SECTION 009112 - ADDENDUM NUMBER 2

- 1.01 DATE: MARCH 11, 2020**
- 1.02 PROJECT: JONES PSC BIOLOGY LABS ABATEMENT/DEMOLITION**
- 1.03 STATE PROJECT NUMBER: H27-6127-LC-A**
- 1.04 GMK ASSOCIATES' PROJECT NUMBER: 19001.01A**
- 1.05 OWNER: UNIVERSITY OF SOUTH CAROLINA**
- 1.06 ARCHITECT: GMK ASSOCIATES**

Jones PSC Biology Labs Abatement/Demolition
Photos of abated Lab Casework Drawers

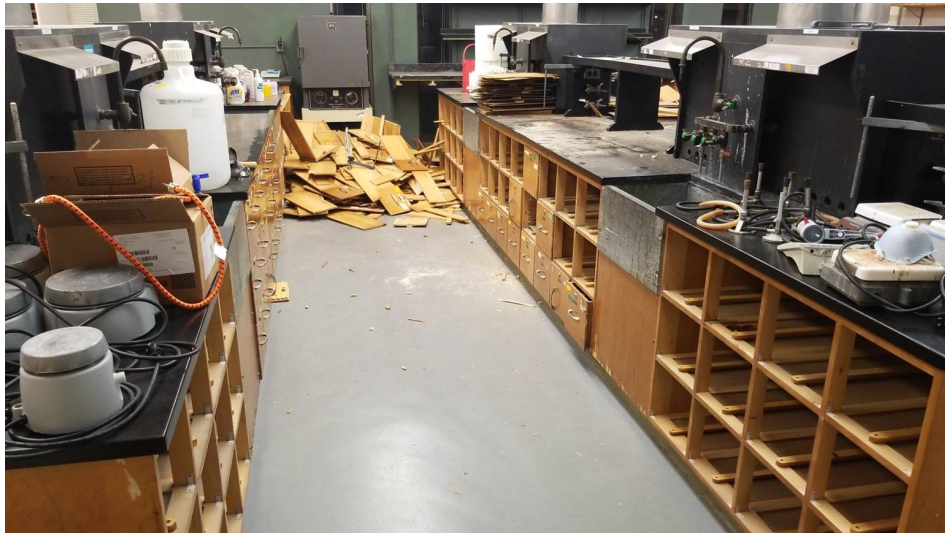
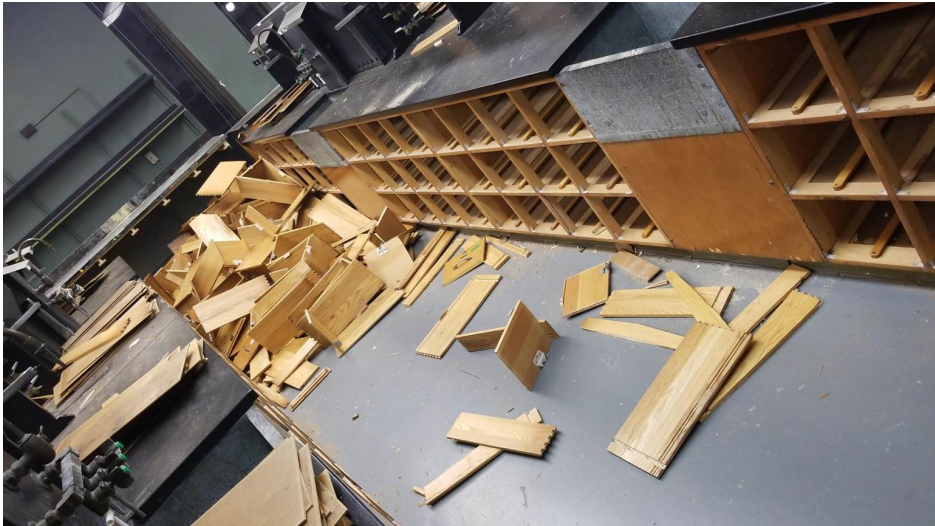
- 4.01 THE OWNER DETERMINED THE DRAWER BOTTOMS IN MANY OF THE LAB BENCHES WERE CONTAMINATED WITH HAZARDOUS CHEMICALS AND ELECTED TO HAVE THE DRAWERS REMOVED DISASSEMBLED AND THE BOTTOMS DISPOSED OF. THE REMAINING PIECES OR THE DRAWERS SHOULD BE REMOVED AS NORMAL DEMOLITION.**

- A. See attached pictures for current state of the labs.
- 4.02 Q: WILL OWNER PROVIDE ELECTRICAL ISOLATION/DE-ENERGIZING FOR EFFECTED WORK?**
 - A. A: No. See electrical drawing ED0.0
